ADDENDUM NO. 1

CSP# 207702

**Org # 194 – K.B. Polk Center for Academically Talented & Gifted -
Renovation**

20 December 2024

SHEET NUMBER
P4.03

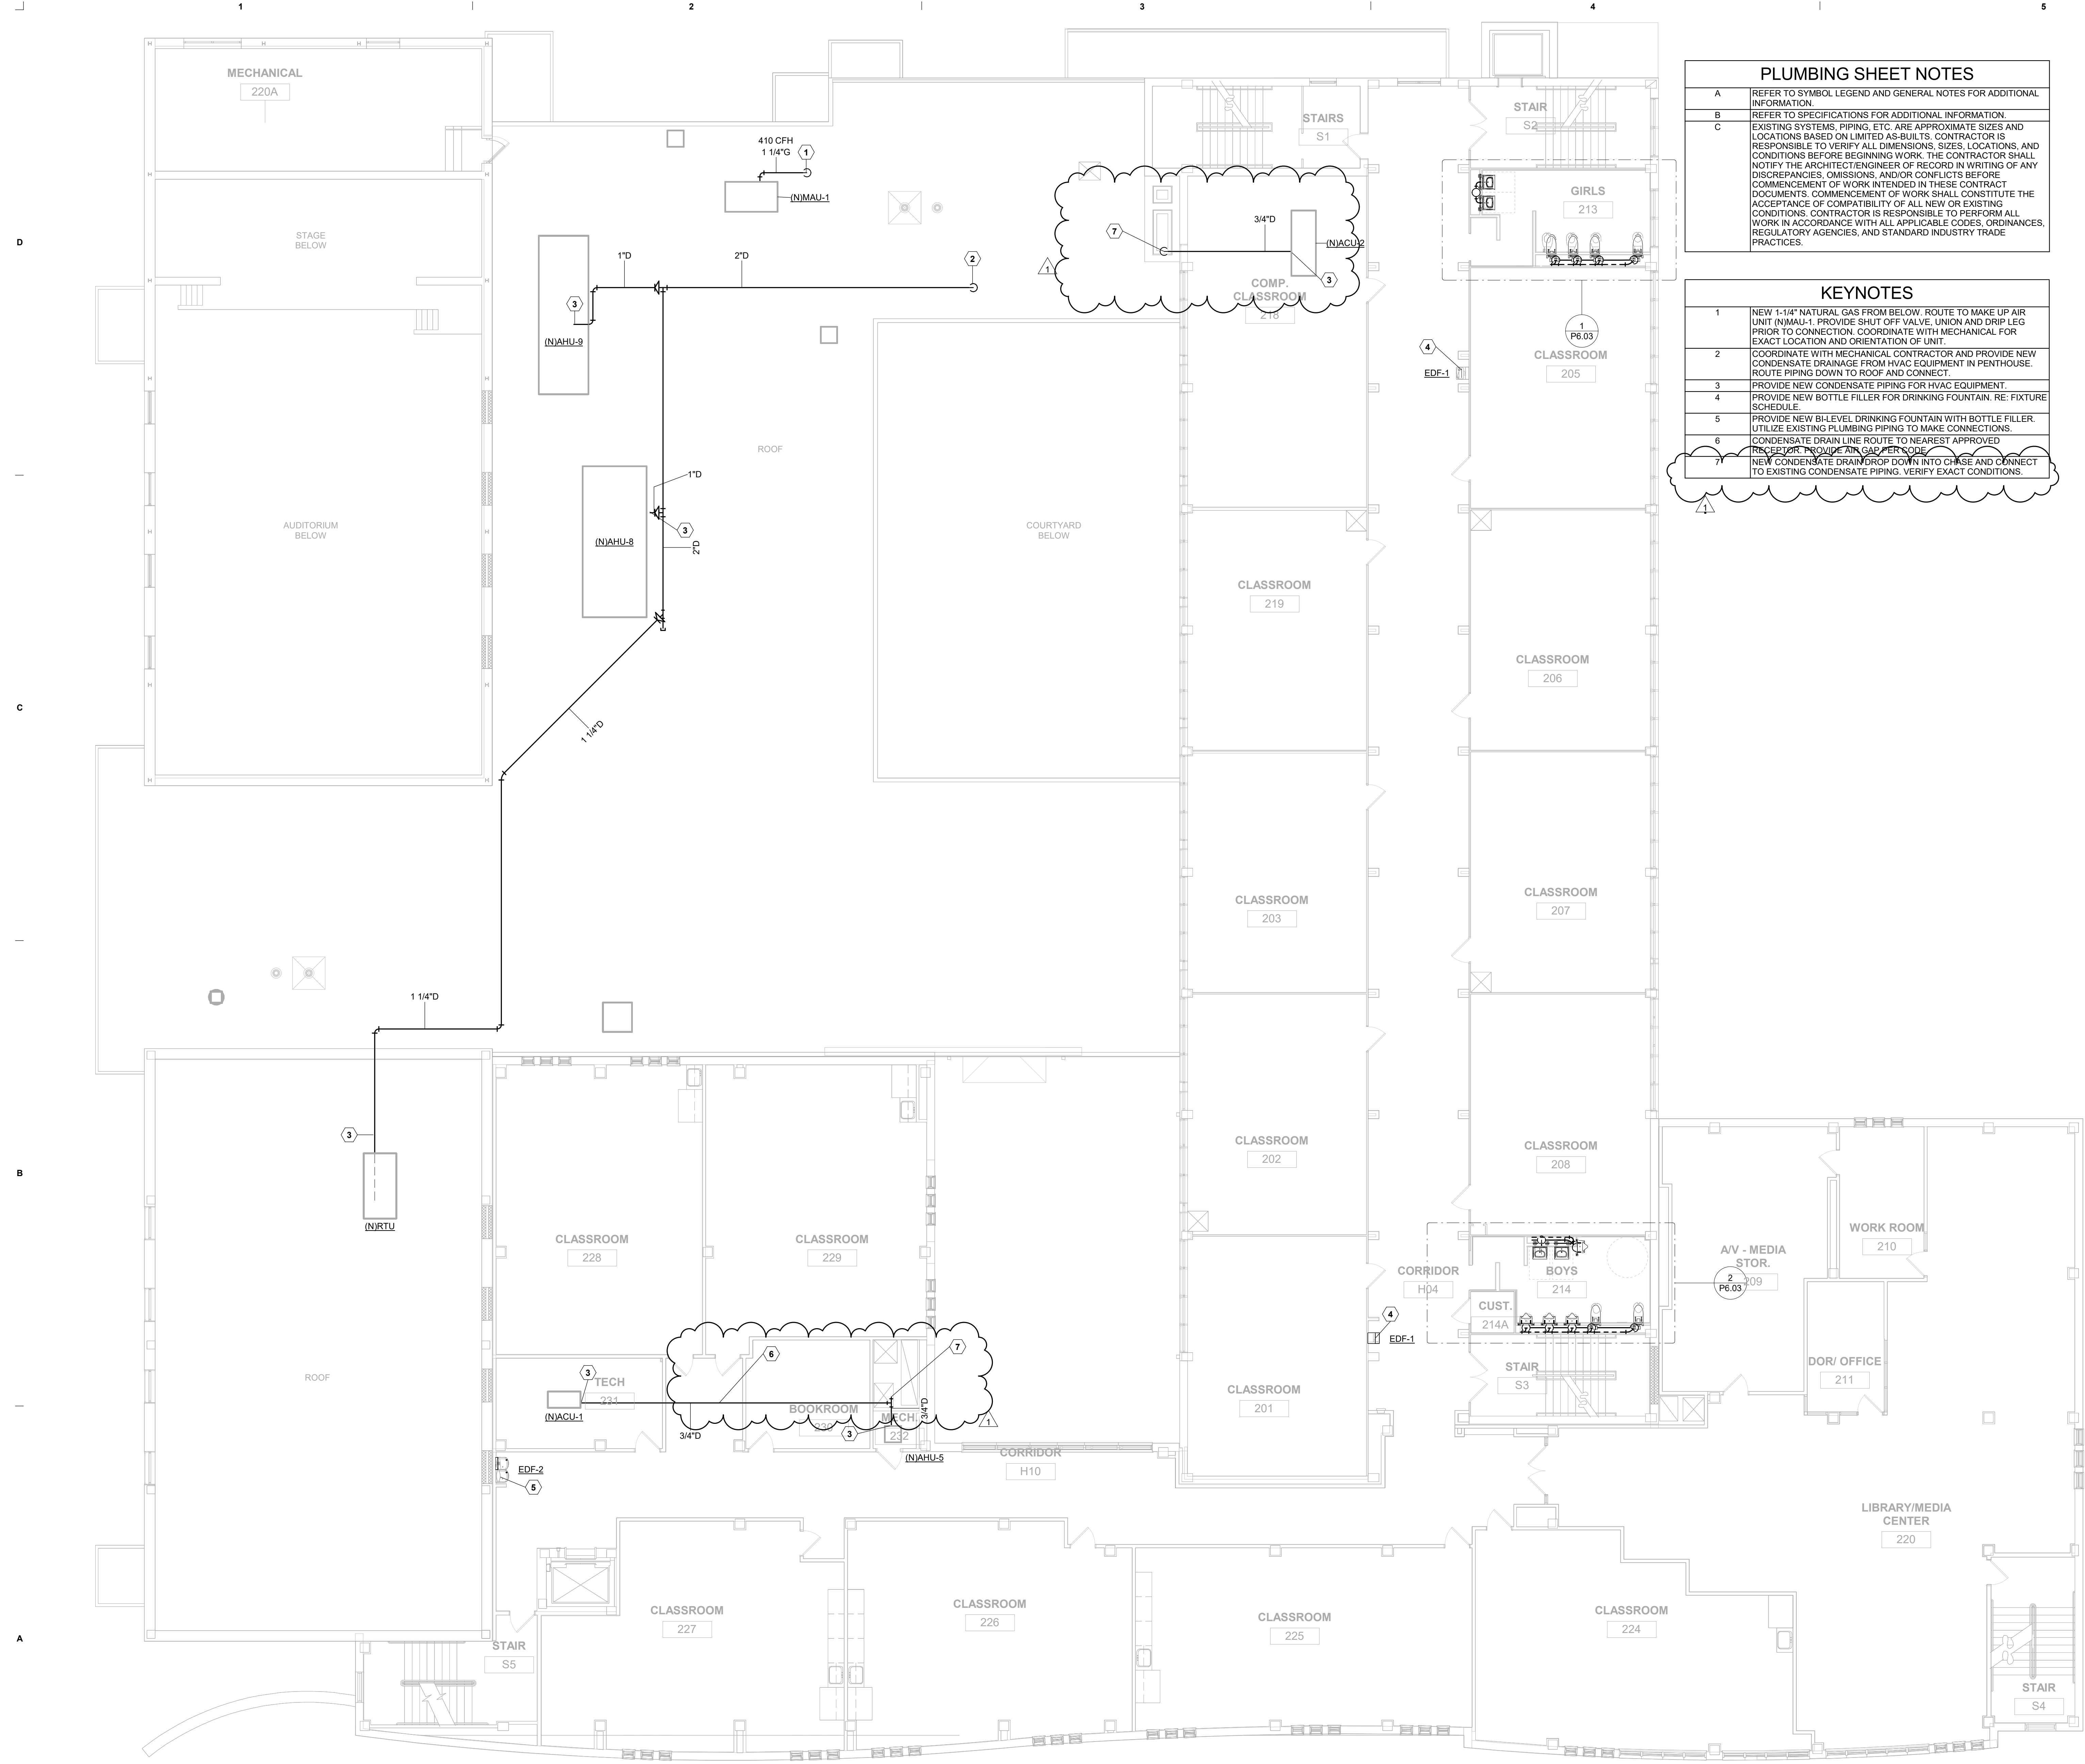
- **Sheet P4.03 – Replace sheet with the revised attached P4.03 PLUMBING – LEVEL 2 OVERALL PLAN**
 - Revised sheet notes and scope per attached sheet.
- **Sheet E5.02 – Replace sheet with the revised attached E5.02 LEVEL 1 LIGHTING PLAN B**

SHEET NUMBER
E5.02

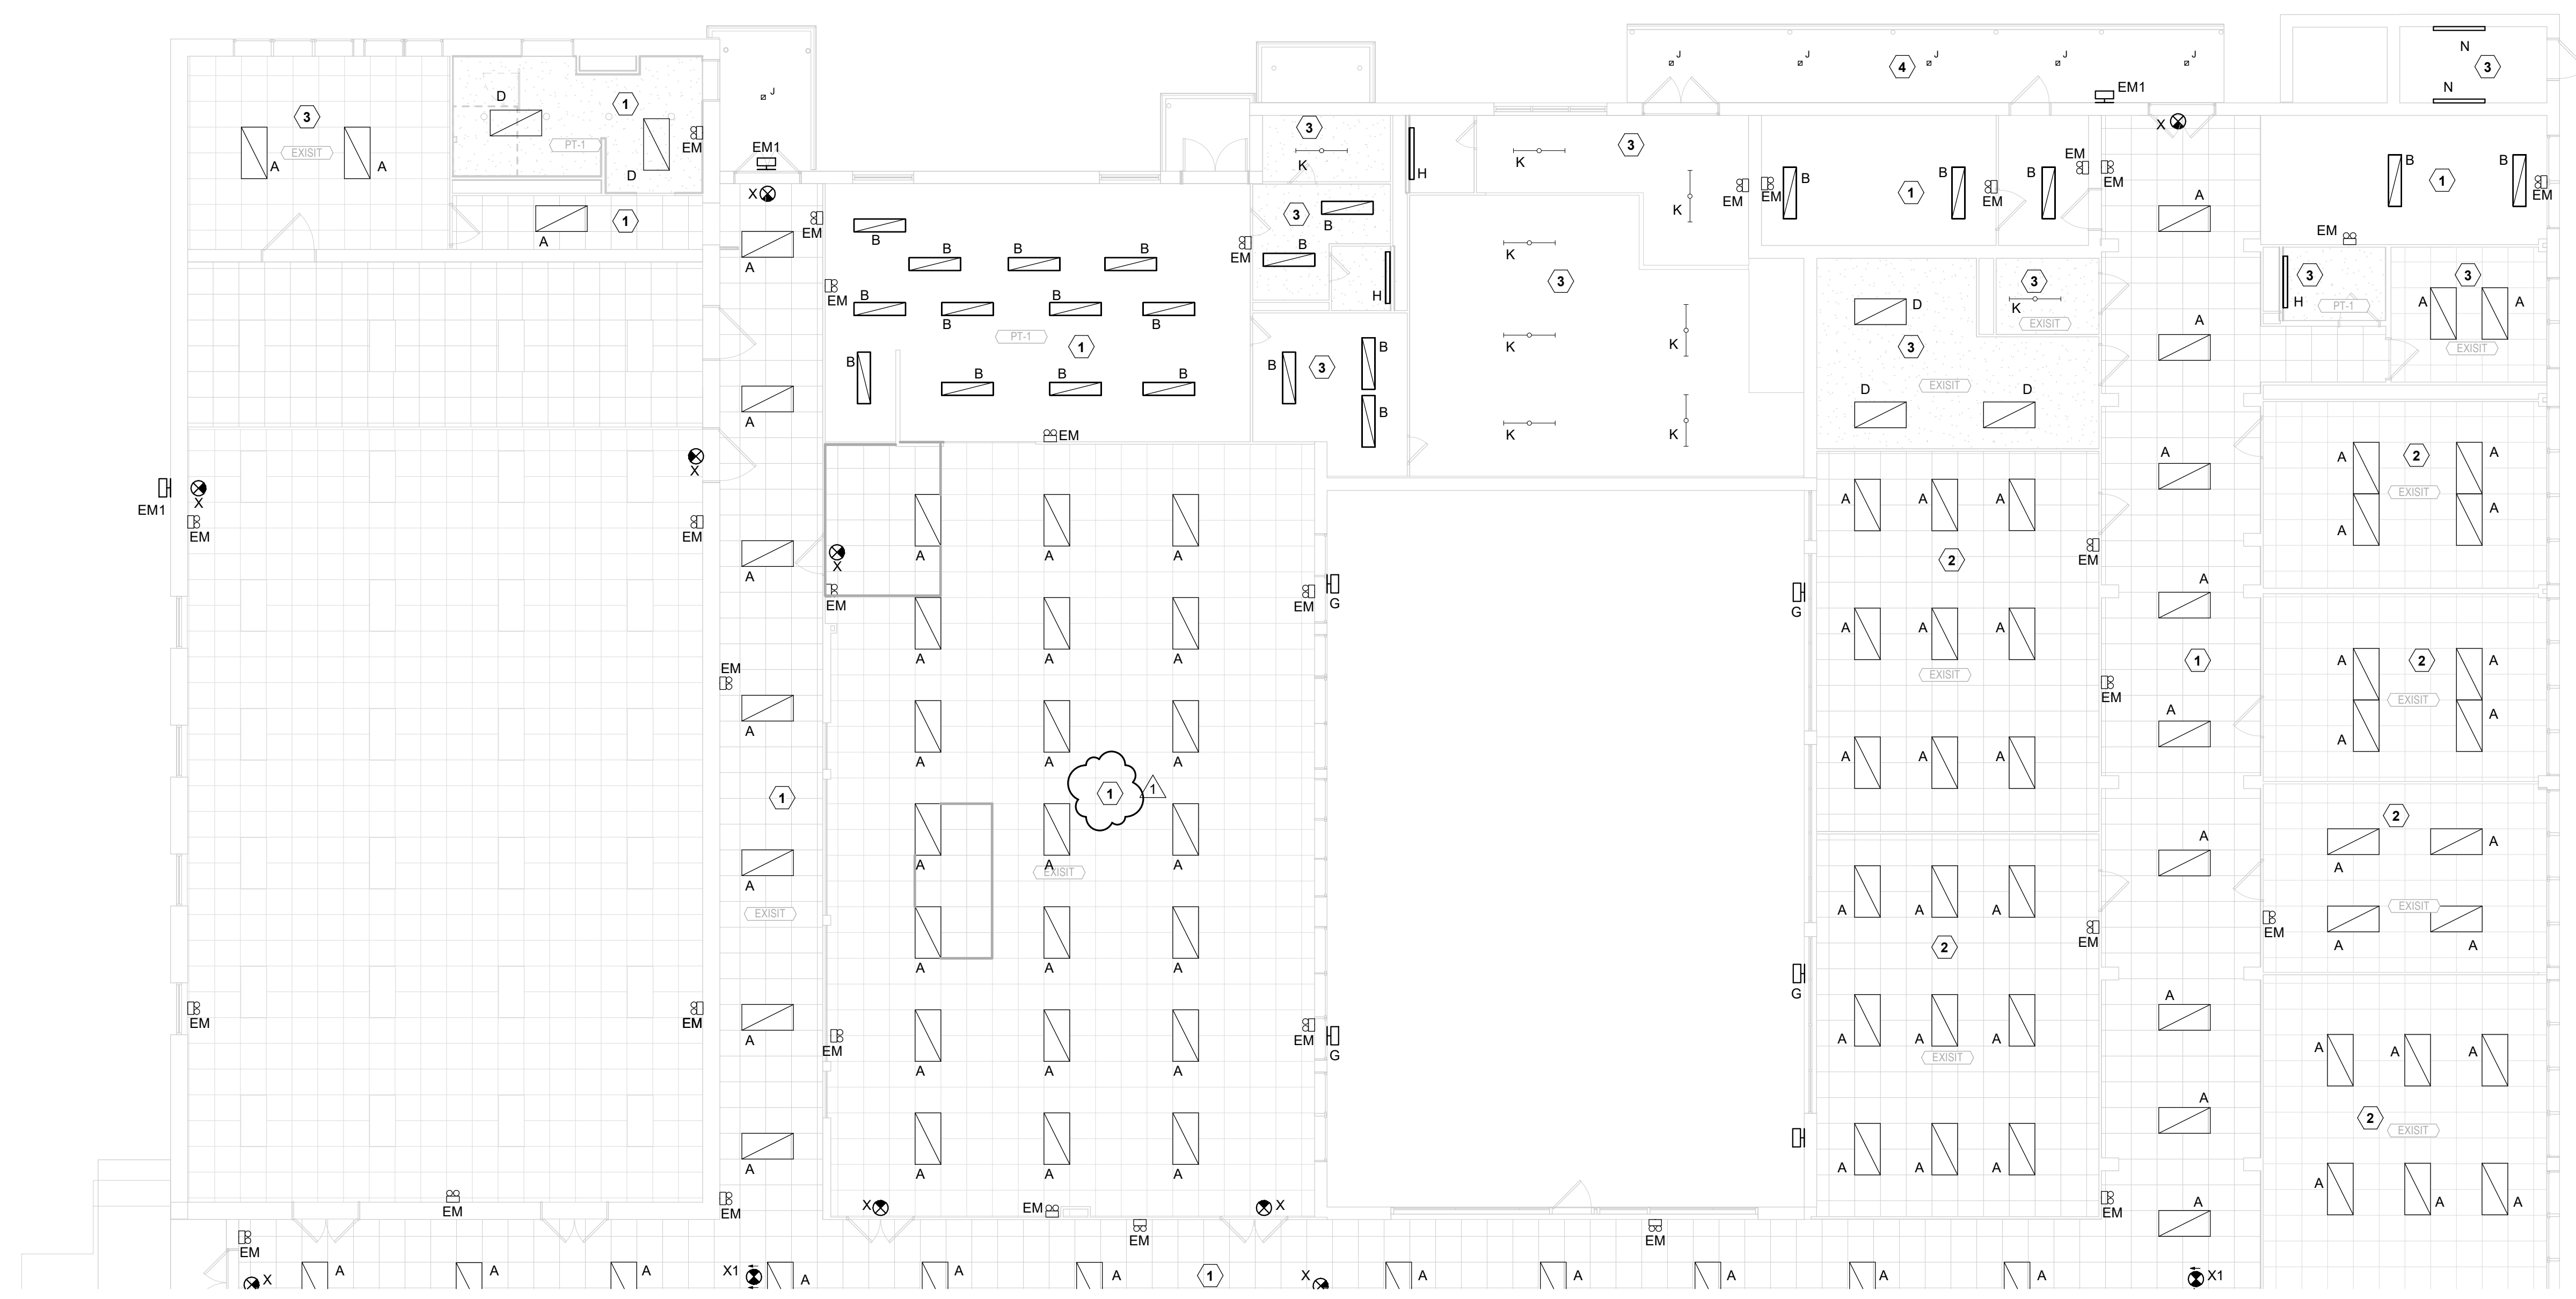
- Revised sheet notes and scope per attached sheet.
- **Sheet E5.03 – Replace sheet with the revised attached E5.03 LEVEL 2 LIGHTING PLAN B**
 - Revised sheet notes and scope per attached sheet.
